Burlington Design Advisory Board

DESIGN ADVISORY BOARD Tuesday September 8, 2020 3:00 PM REMOTE MEETING

TO: Design Advisory Board
FROM: Scott Gustin
DATE: September 8, 2020
RE: 21-0119CA, 81 Crescent Beach Drive
21-0121CA, 71 Crescent Beach Drive

To: The Design Advisory Board
From: Ryan Morrison, Associate Planner
RE: ZP21-0099CA; 88 Locust Street
Date: September 8, 2020

New design
West elevation

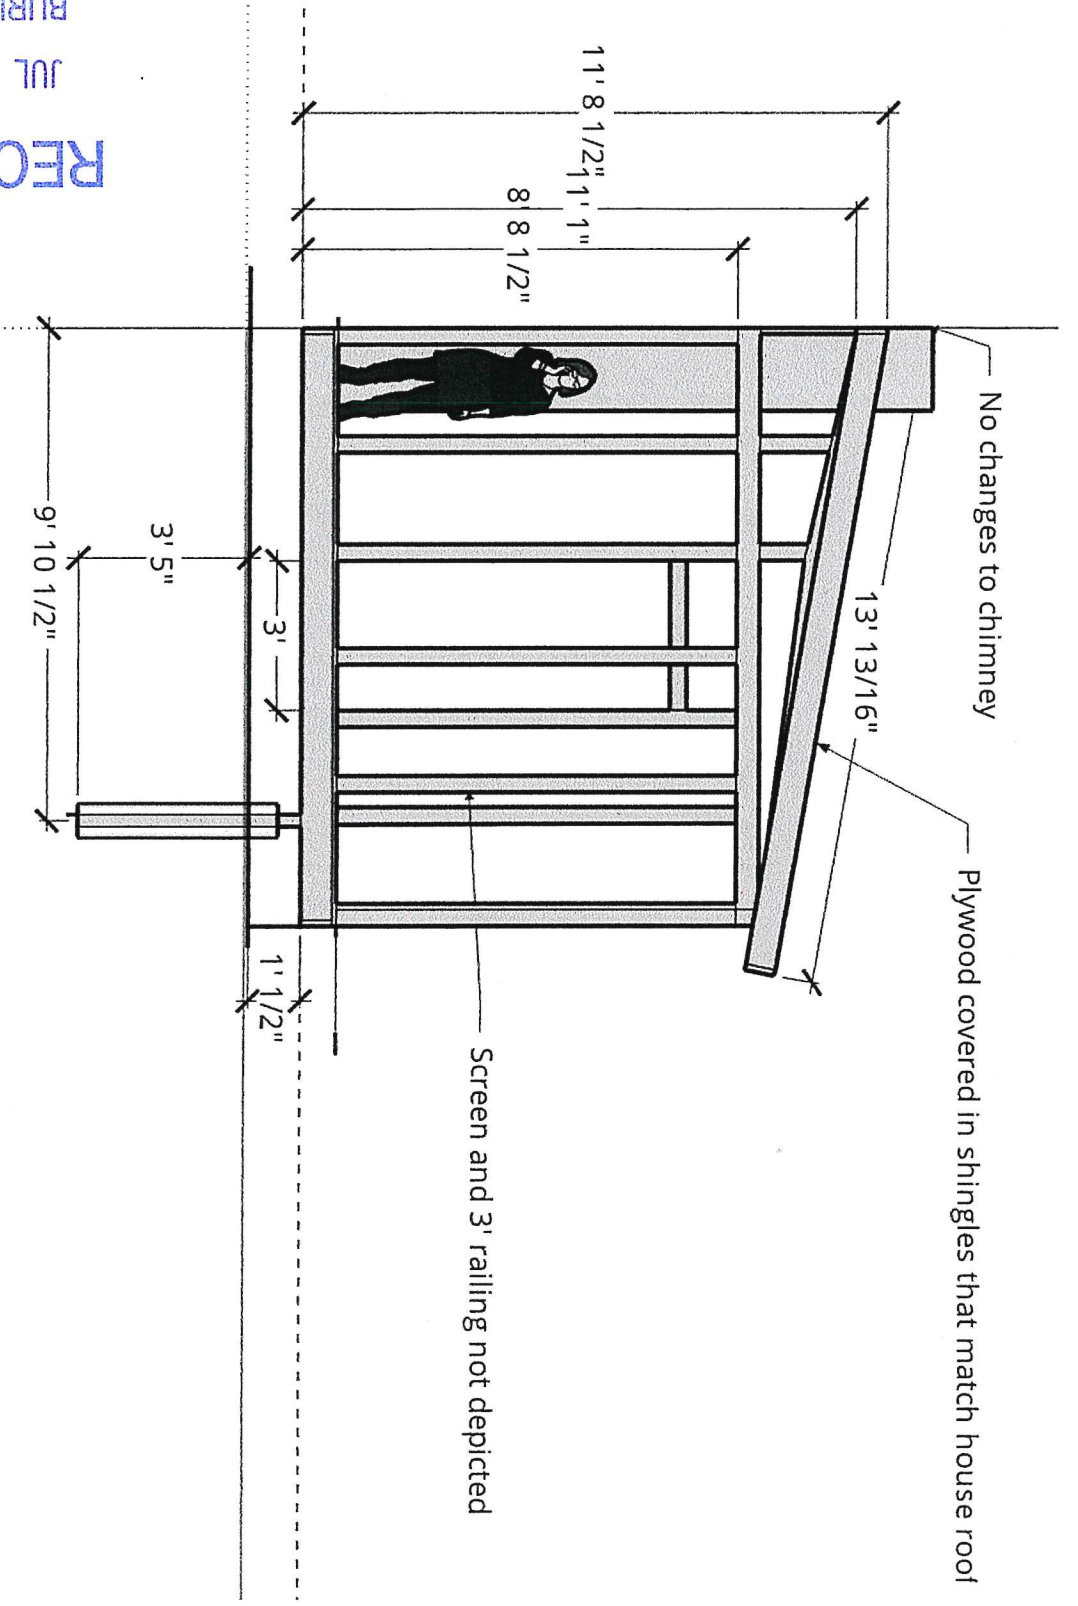
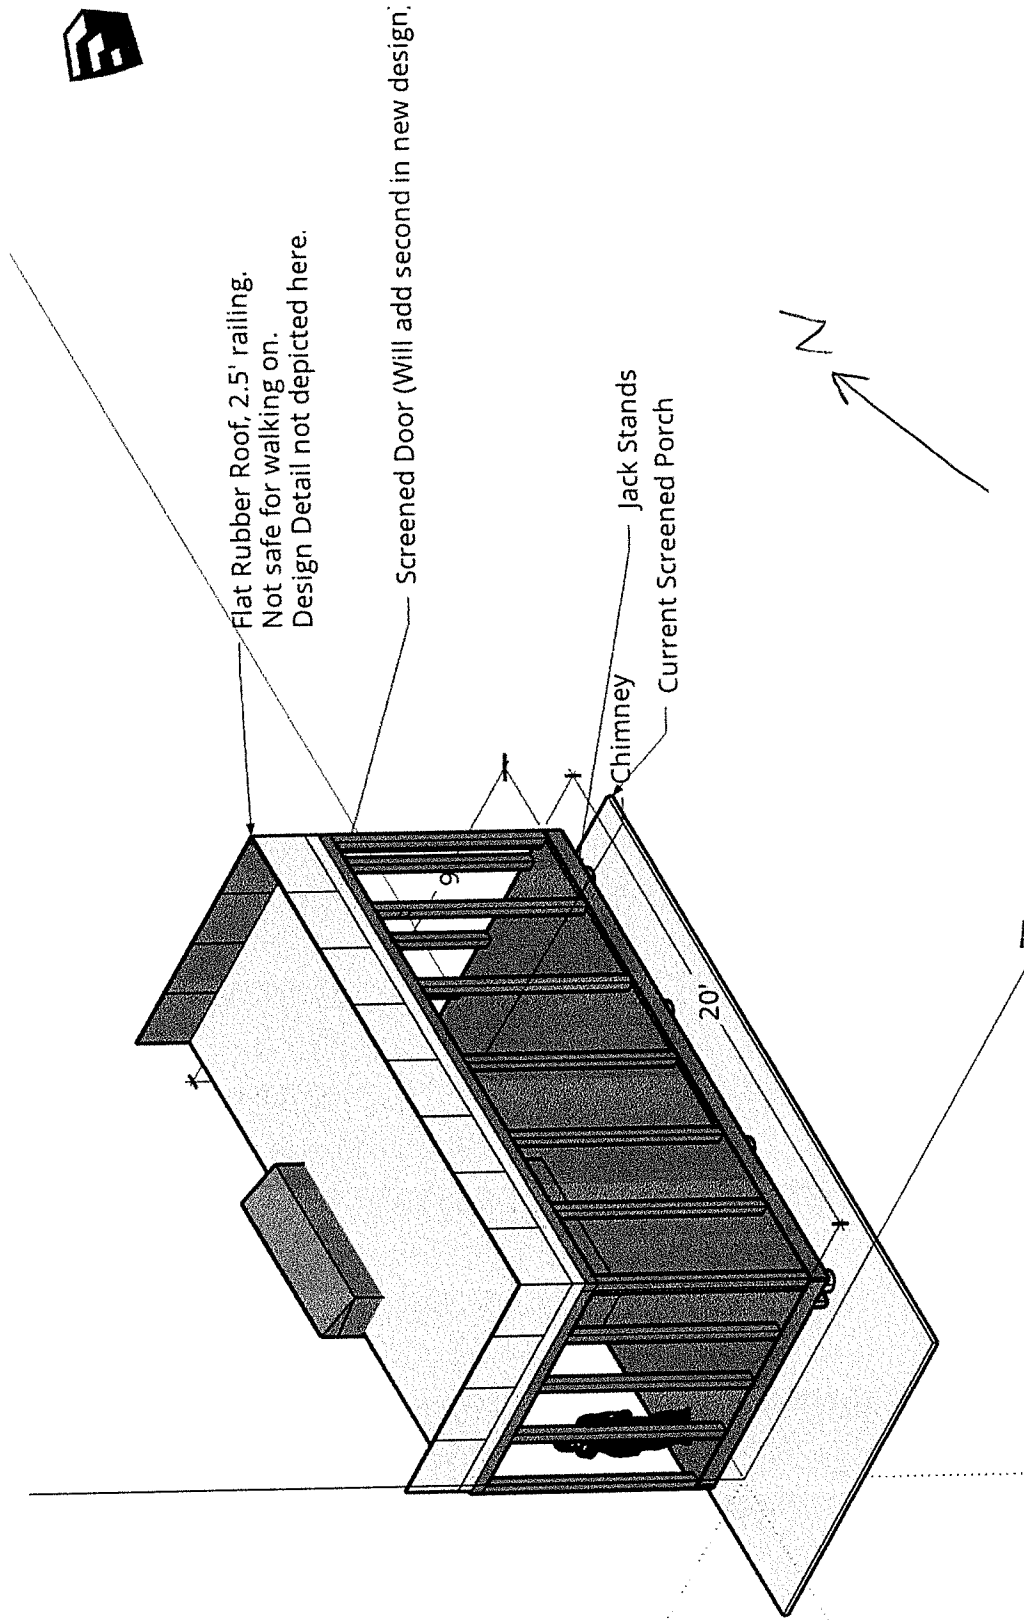
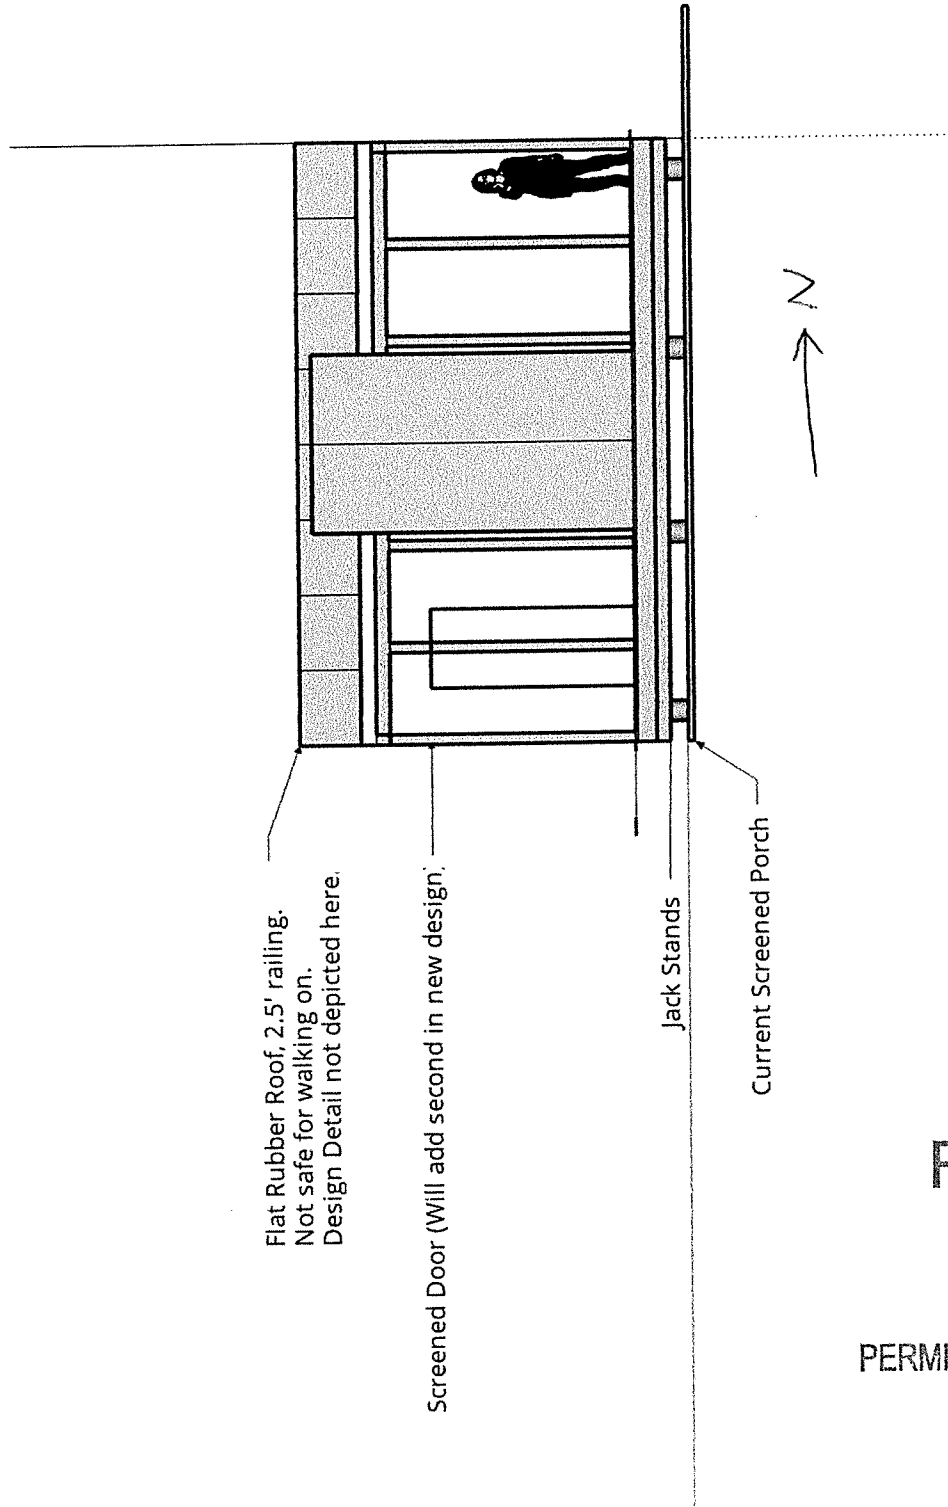
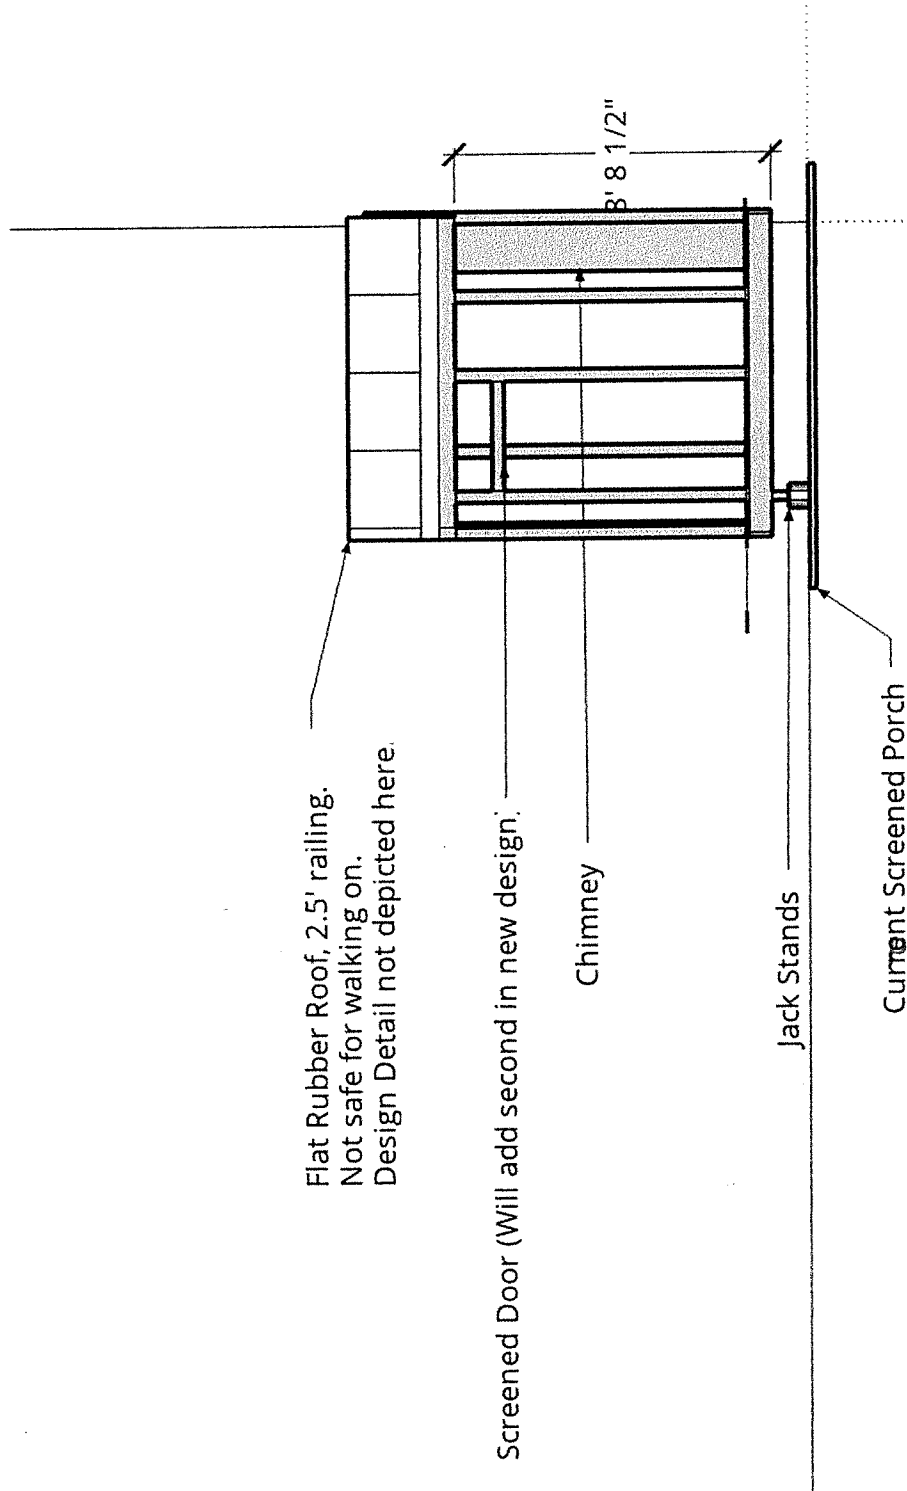
With the lack of a rooftop railing system on the replacement porch, an aspect of the historical appearance will be lost. As noted above, it appears feasible to add a rooftop railing to preserve the porch's historic appearance and to act as a screen to the sloped roof.

As noted above, the existing rooftop railing system will be lost with the replacement porch. It appears that a similar railing system could be included on the porch roof, and as an added bonus, could provide a level of screening to the sloped roof. The applicant proposes a sloped roof to aide with the snow load – with the idea that snow will slide off to the east.

- The existing porch has a rooftop railing system with intricately designed balustrades. The proposal omits rooftop railings. It appears that if similar railings were added to the new roof, they could provide partial screening to the sloped roof while maintaining a historic appearance. This would be of particular importance when considering its visibility from the street. The applicant's concern is in regard to snow loads, and the roof's ability to facilitate snow to slide off to the east. While a similarly designed railing would prevent snow from sliding off, perhaps the railing on the east side could be gate-like and allow for the property owner to open it and allow for easy snow removal.
- The proposal should include landscaping around the new porch.
- With the exception for non-visible substructure, the replacement porch shall not utilize pressure treated materials.

DRAWING TITLE:
LANDSCAPE PLAN

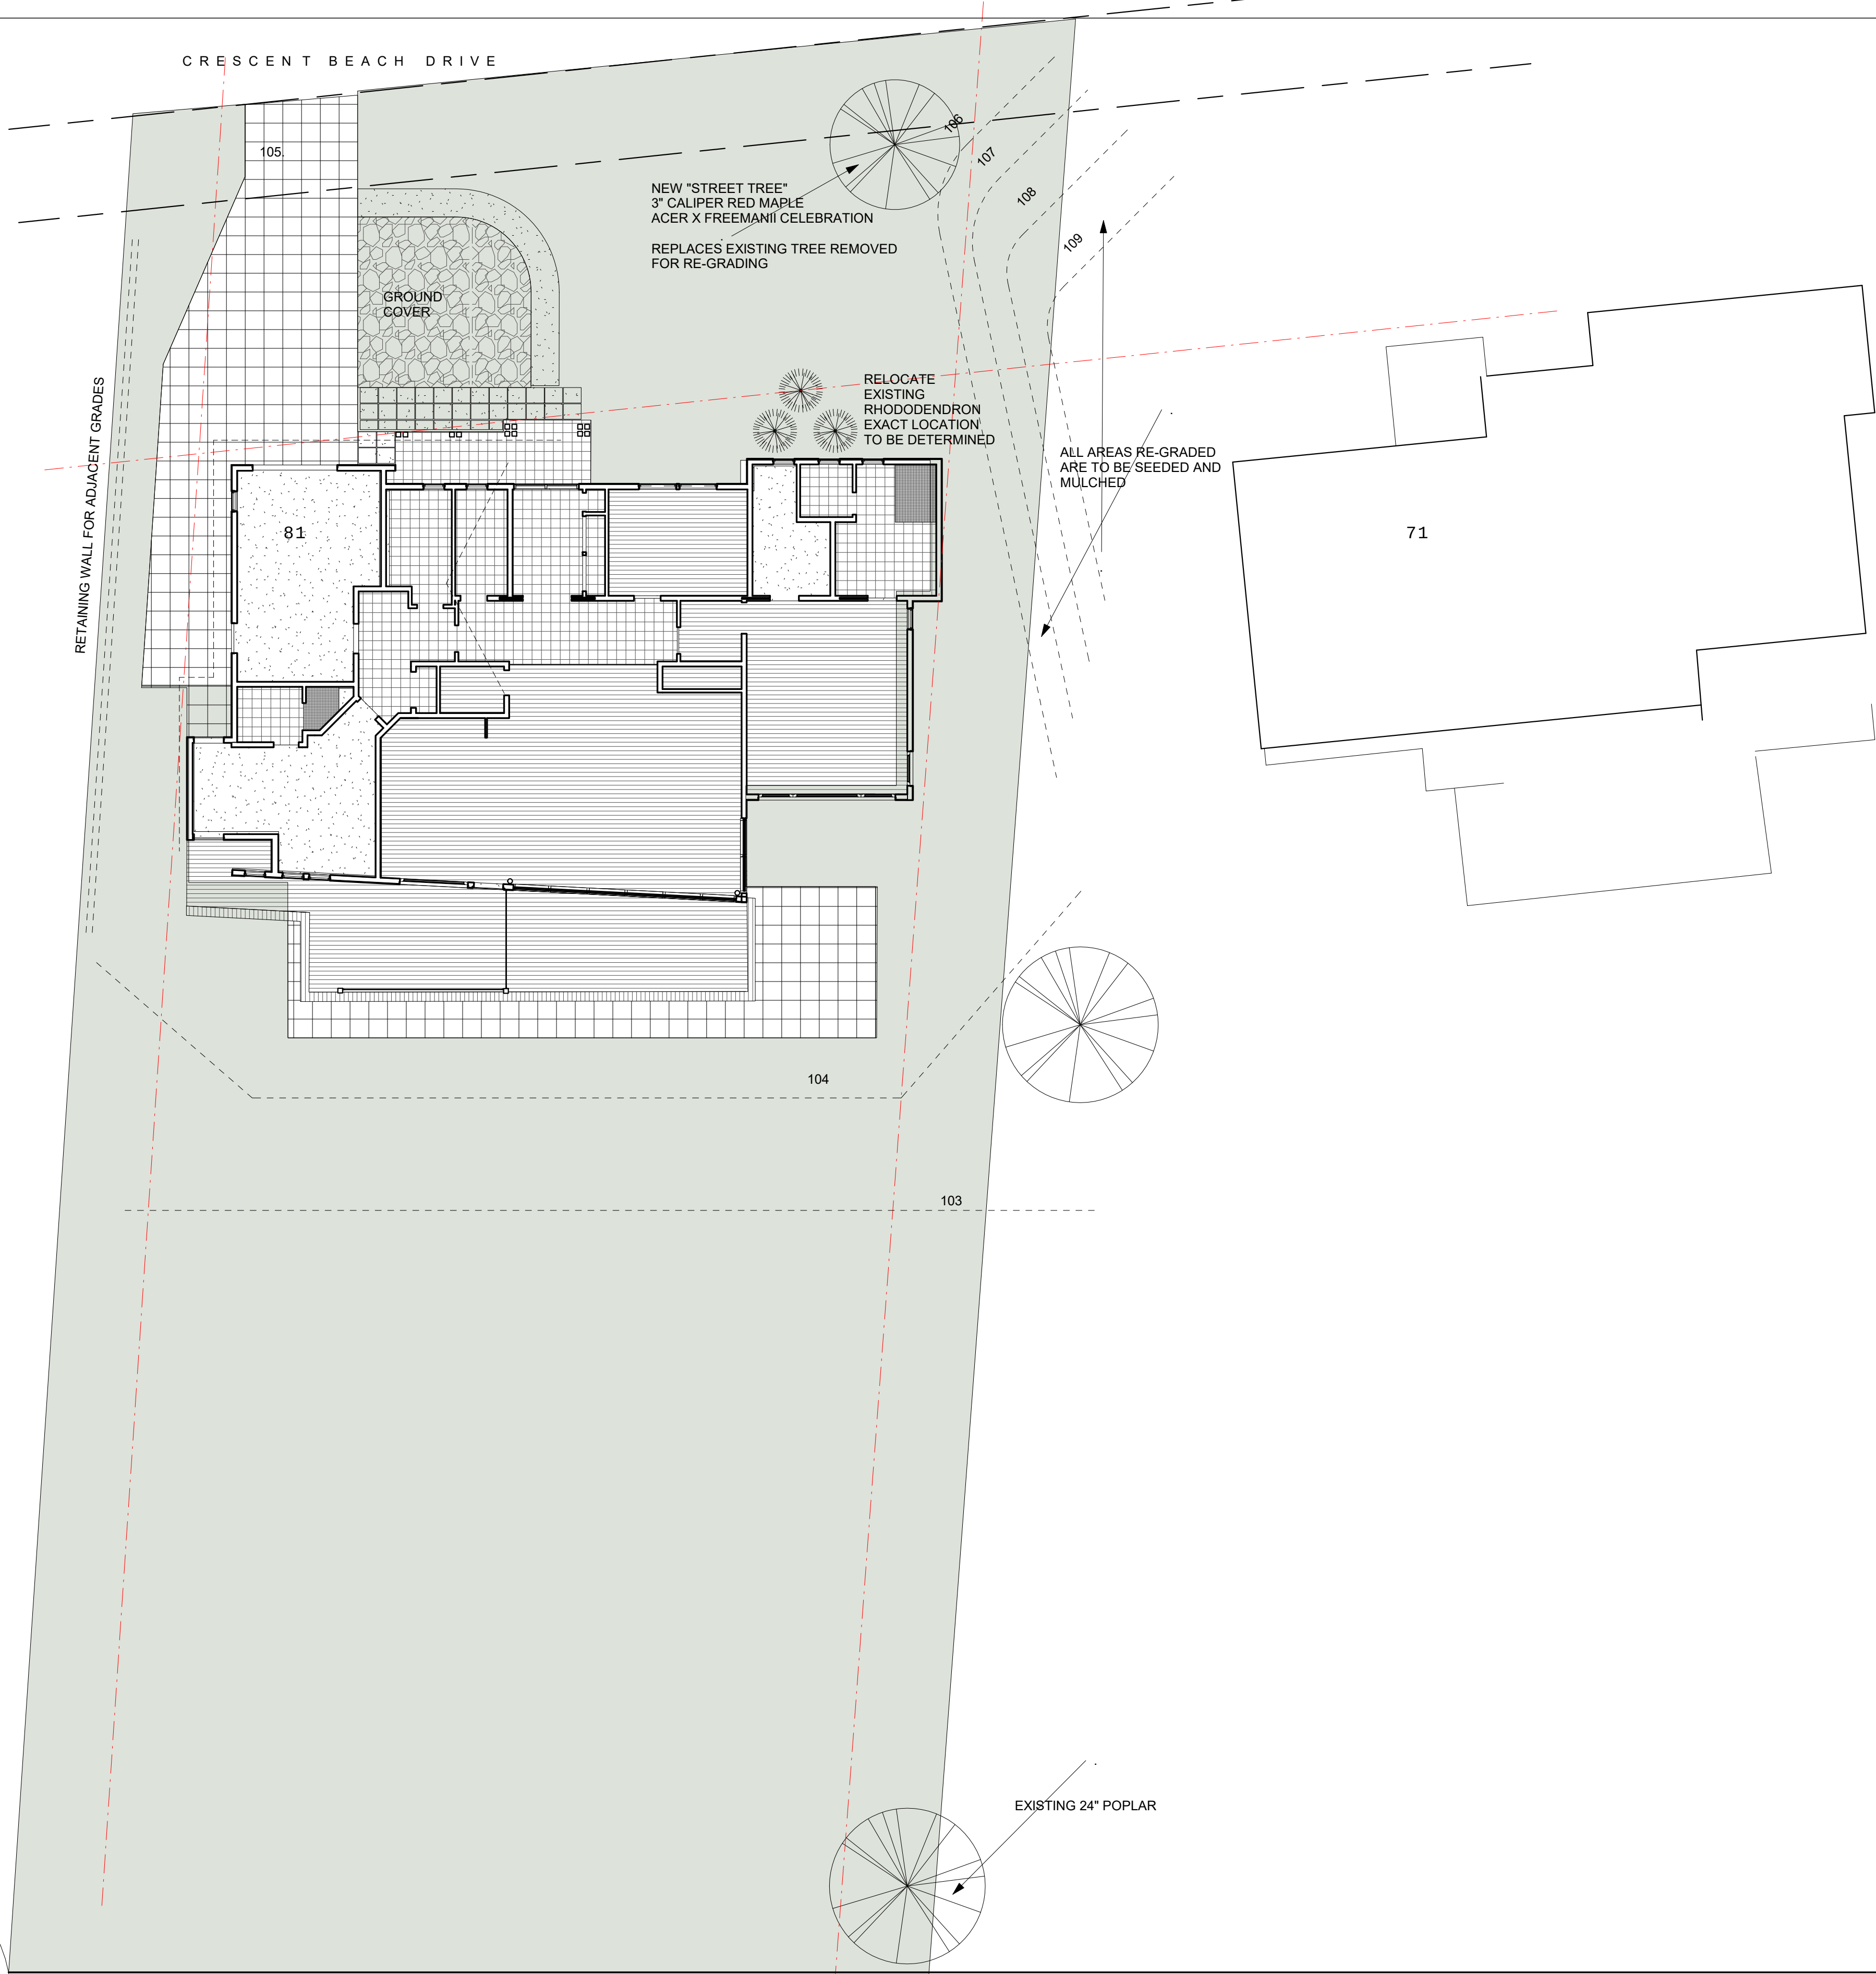
similar to existing conditions. A new retaining wall is proposed along the northwestern end of the property. Details as to materials and dimensions are needed.

New landscaping is focused in front of the proposed home. A new area of ground cover vegetation is proposed alongside the revamped driveway and front entrance. Several existing rhododendrons will be relocated along the front of the new home as well. The site plan notes a new “street tree” (a red maple); however, it appears to be located within the bounds of the private property. Such location is acceptable for a new tree; however, it is not a street tree located within the street right-of-way. As noted previously, a new retaining wall is proposed along the northwestern end of the property. Dimensional and material details are needed.

1. Provide dimensional and material details for the proposed retaining wall.
2. Details as to window and porch column materials, utility meter (and mechanical equipment, if applicable) locations and screening are needed.
3. The front walkway should be extended to the street.
4. Depict the boundaries of the lakeshore buffer zone on the site plan.
5. Complete and submit the small project erosion control form and residential stormwater management questionnaire.
